Government of India-Ministry of Railways  
Research Designs & Standards Organisation  
Lucknow - 226 011  
DID (0522) 2450115  
DID (0522) 2465310

MODIFICATION SHEET No. RDSO/2010/EL/MS/0388 Rev.'0'  
Dated 23.07.2010

- 1.0 Provision of additional 1000 LPM compressor in WAP-4 class of Electric locomotive with segregated pneumatic valves layout arrangement.
- 1.1 Provision of additional 203 Litre air reservoir in series with existing 203 Litre reservoir and replacement of existing 53 Litre capacity auxiliary reservoir by 100 litre reservoirs in WAP-4 locomotives

ADDITIONAL 1000 LPM COMPRESSOR MOUNTING LOCATION ON WAP-4 LOCOMOTIVE  
WITH SEGREGATED PNEUMATIC VALVE

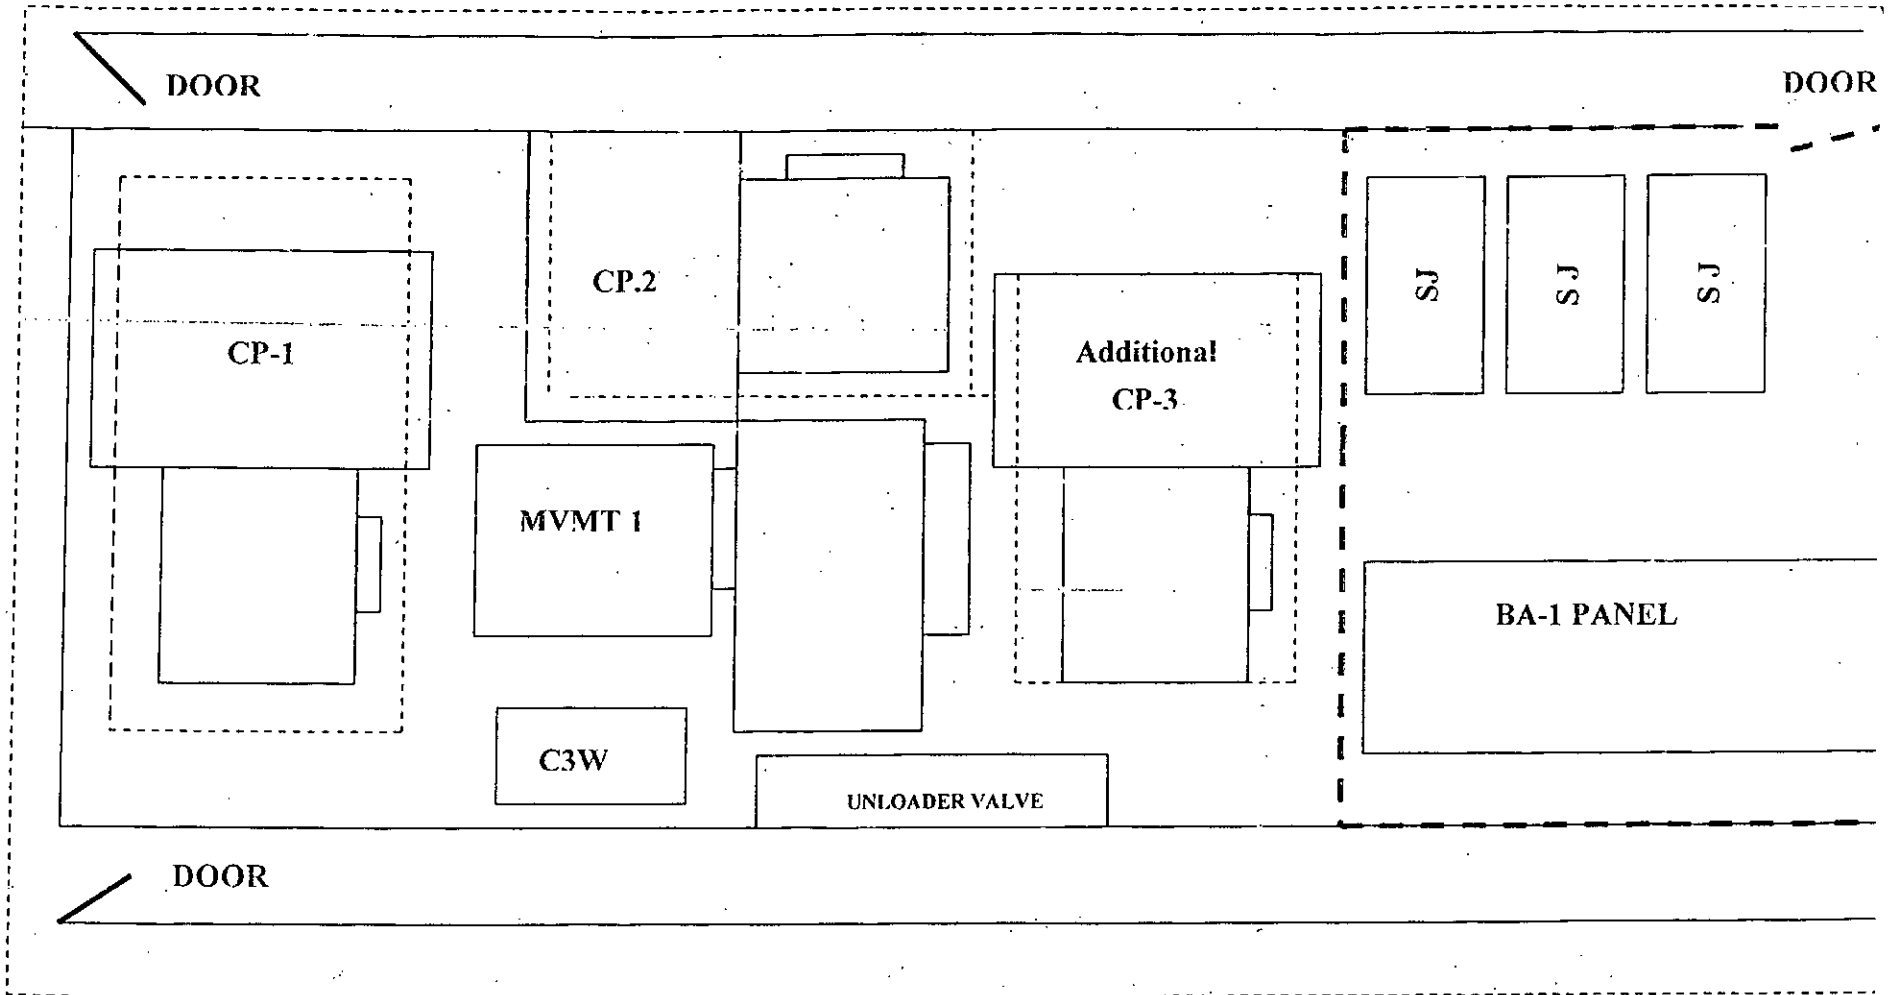
- i. Provision of 1000 LPM capacity compressor in existing space in front of MVMT-1 on two additional mounting channels size 150 x 75 x 10thk. x 1600mm length as per IS:2062 to be

diagonally welded on long beam of the locomotive at distance between the channel 350 mm. as shown in the enclosed sketch-1

- ii. Compressor mounting pad of size as same as pads in other existing compressor with 14mm Ø tapped hole to be welded on the channel at a distance of 350 x 800 mm.

- iii. Oil tray of existing size 920mm x 400mm to be fixed up below the compressor unit.
- iv. The Existing Compressor unit -2 needs to be shifted by about 300 mm towards Cab-1 end and the complete unit is required to be rotated by 180° for feasibility of compressor motor terminals.

- v. With the rotation of compressor unit-2, the clearance with stool of MVMT-1 is reduced. To maintain proper clearance for maintenance point of view, top plate of the MVMT-1 stool shall be chopped off by about 25mm.

PIPE LINE ARRANGEMENT OF WAP-4 LOCO NO. WITH SEGREGATED PNEUMATIC VALVES

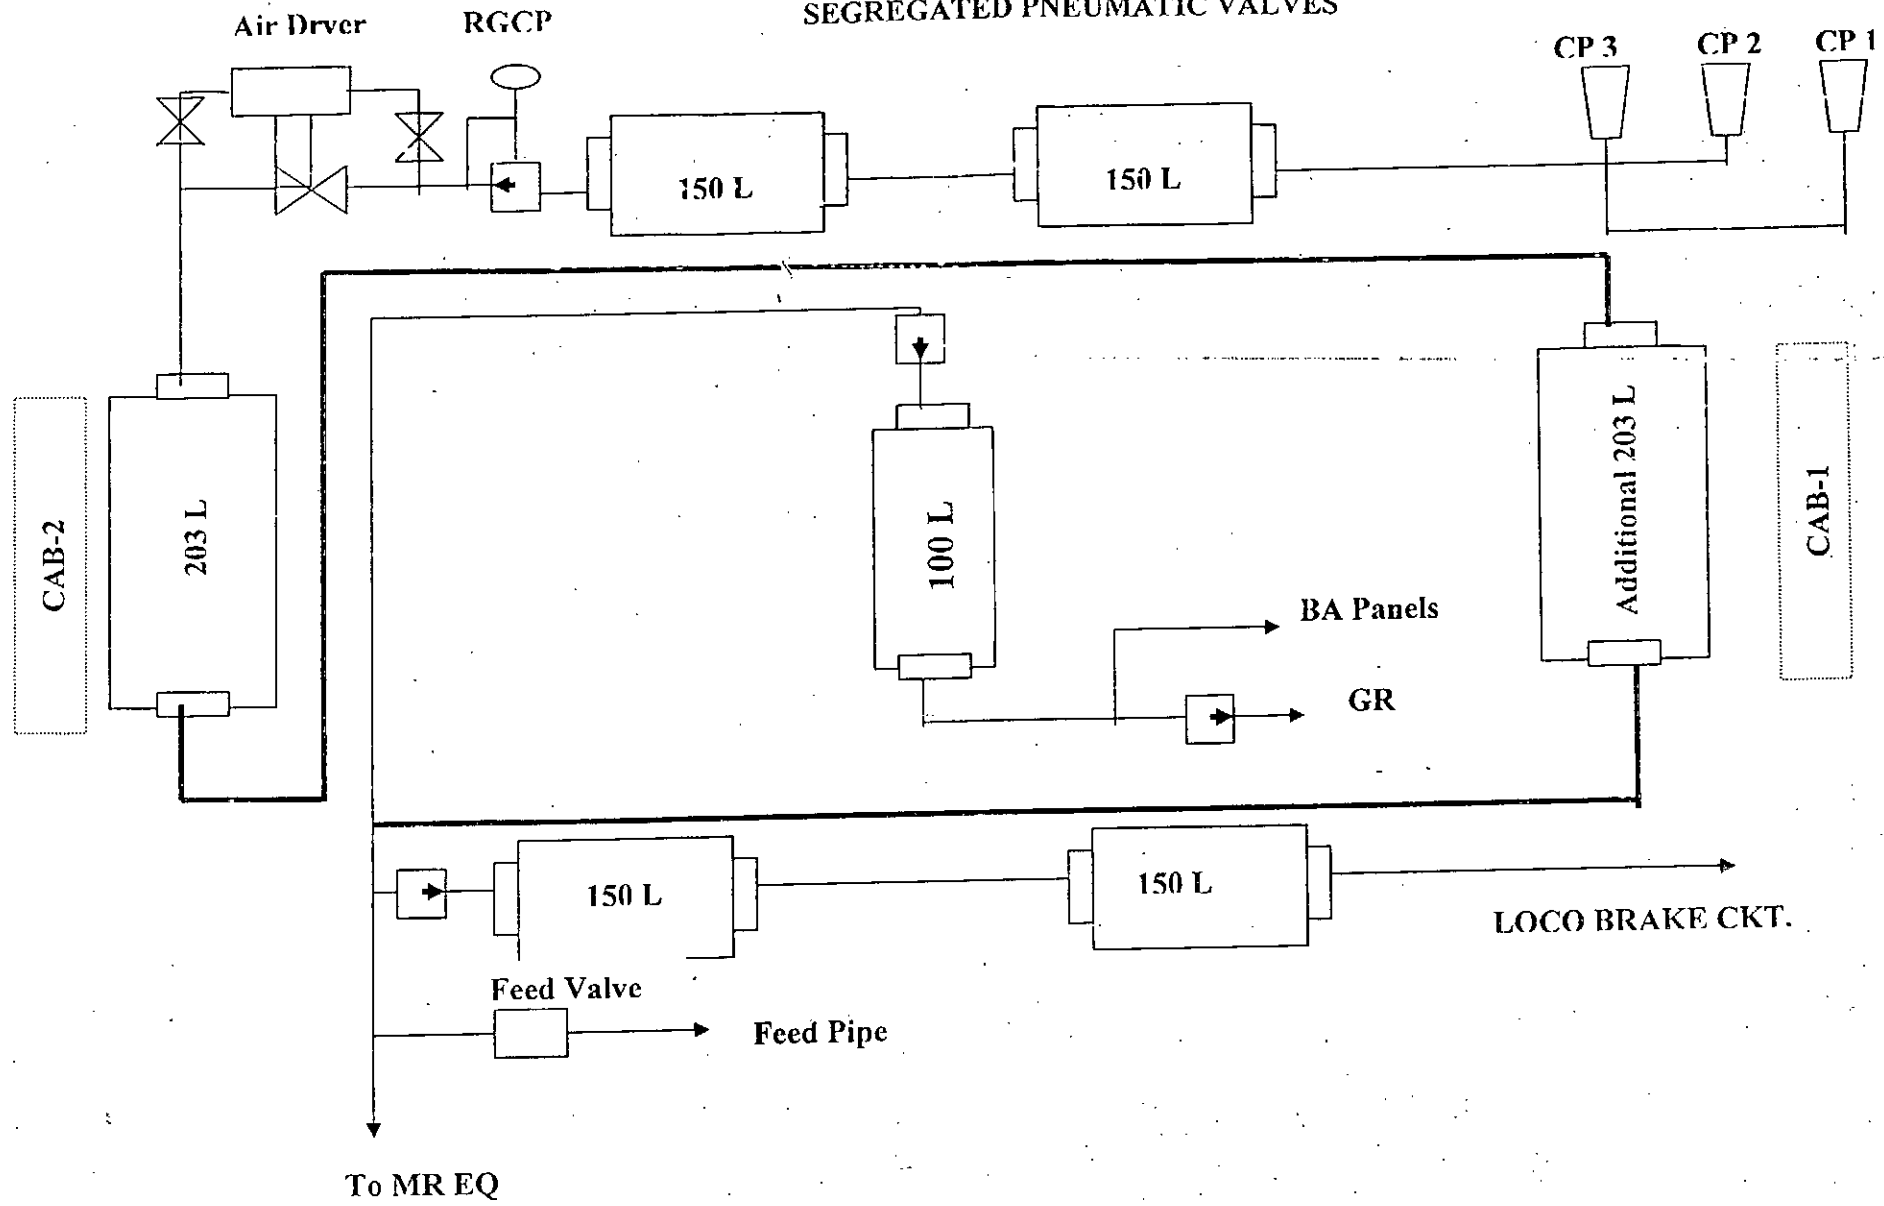
- vii. An additional magnetic un-loader valve is to be mounted on the existing bracket of other compressor's unloader valves.
- viii. An additional reservoir of 203 Litre capacity has to be fitted under Cab-1 at similar location as existing 203 Litre is fitted under Cab-2. The MR equalizing and Feed Pipelines tapping shall be changed after this additional reservoir of 203 Litre as shown in the sketch -2.
